# Evitex Apparels limited Extension

### Observation 1: Missing information in the design report (Warehouse Extension Building).

### Observation 2: Live load not mentioned for suspended slab of ground floor (Warehouse Extension Building).

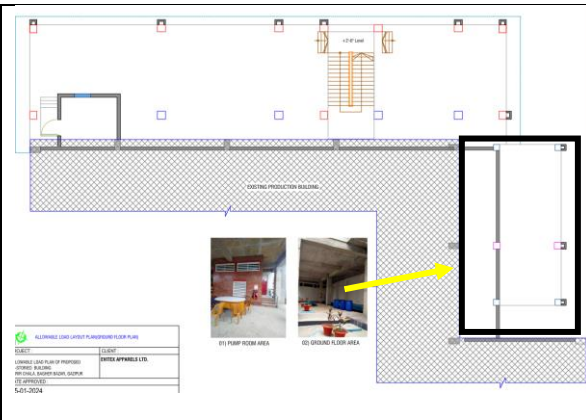
**Description:** A septic tank is made below the ground floor of Part-2, but the live load is not shown in the load plan for that suspended ground floor slab. The building engineer is required to update the live load plan for all suspended slabs.

#### COLUMN LAYOUT PLAN

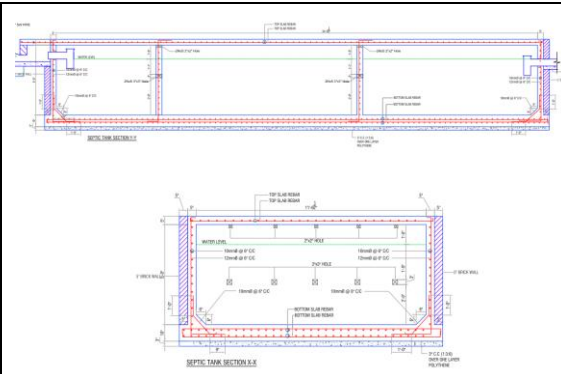
**Description:** Column details of the 2<sup>nd</sup> floor level are not provided in the column schedule. Also, the position of the septic tank to the existing footing is not clearly shown in the drawing. The building engineer is required to update the as-built drawing showing all missing information.
